## PRODUCT UPDATE BULLETIN

15-0004

## PREVENT DAMAGE WHEN INSTALLING TRANSIT BULKHEADS

## Low-roof Transit Bulkheads (96301-3-01, 96302-3-01)

LOW ROOF PASSENGER'S SIDE

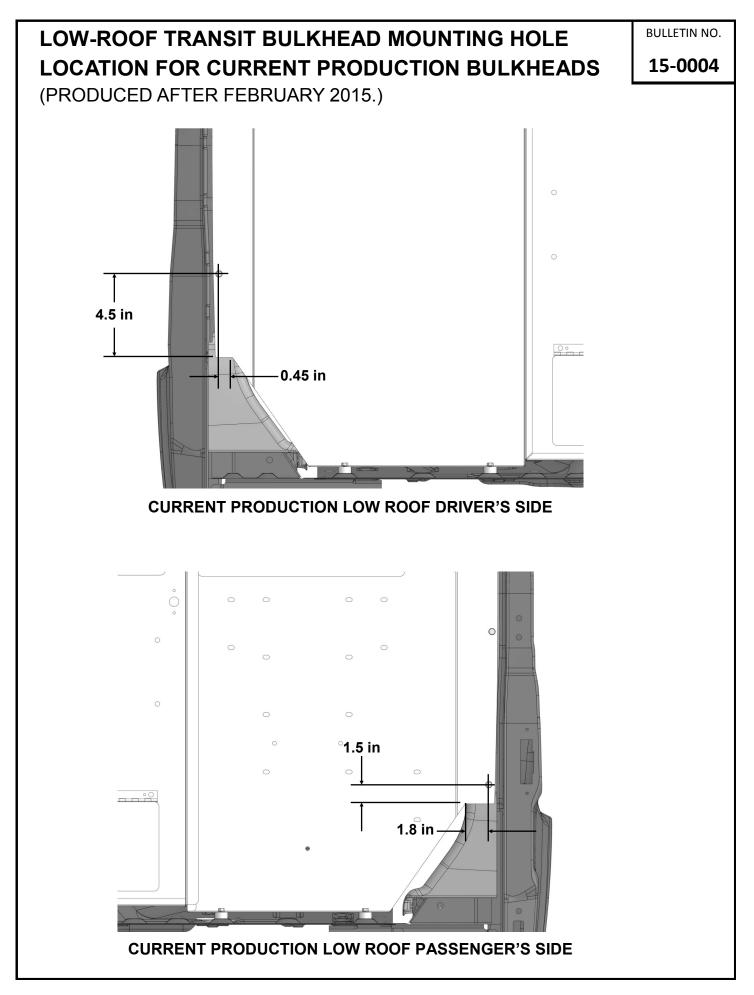
Weather Guard Transit implemented a change in January 2015 to Low-roof Bulkhead models 96301-3-01 and 96302-3-01 relocating the lowest mounting holes on the side panels to increase the clearance between seat belt retractor and the blind fasteners as shown in the figures below. The lowest mounting hole on the driver side mounting panel needs to be at least 4.0 inches above the bottom corner of the bulkhead panel. The lowest mounting hole on the passenger side mounting panel needs to be no more than 1.5 inches above the bottom corner of the bulkhead panel. Using these hole locations the mounting hardware and blind fasteners are above or below the retractor mechanism.

Check the hole location of low-roof Transit bulkheads. If they are not the same as current production, drill new lower mounting holes as shown on page 2 of this bulletin.
